ADDENDUM #1

Cherokee Nation Prison Museum

Anishinabe Design Project Number C40123

1 SITE PLAN
 SCALE: 1" = 10'-0"

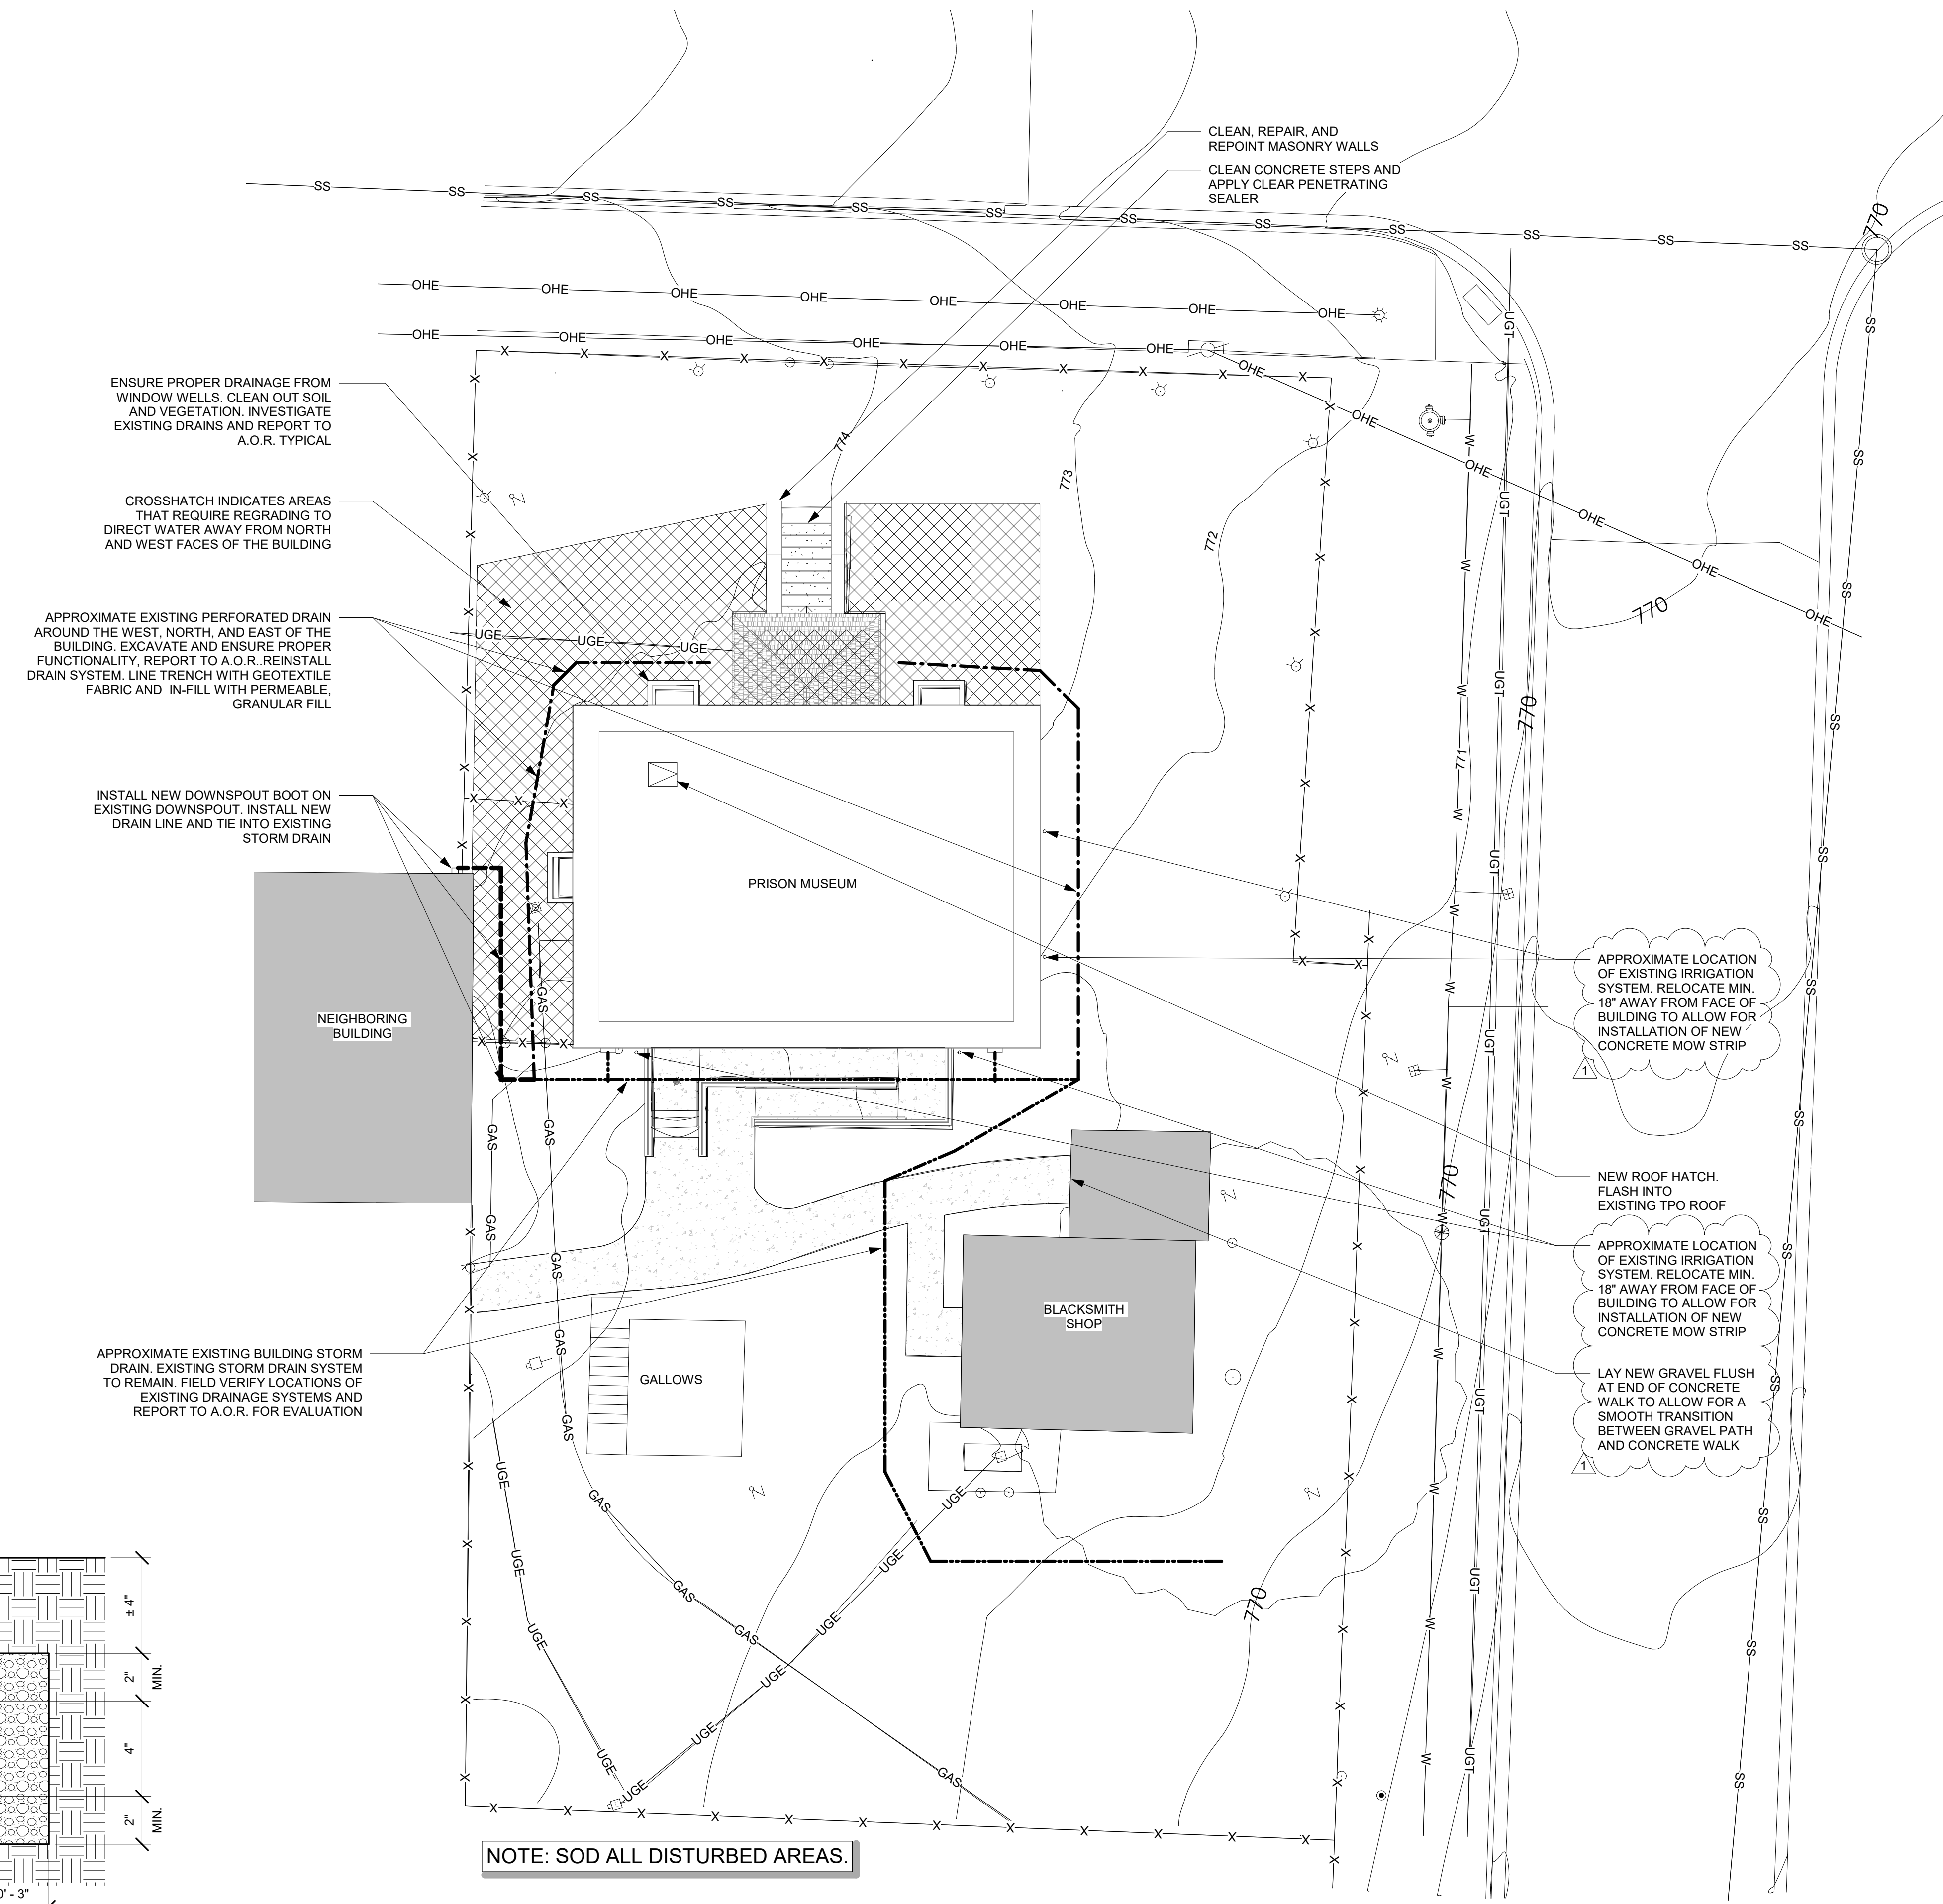
1. SHEET A101:
Replace Sheet. Indicates irrigation system location and added gravel.
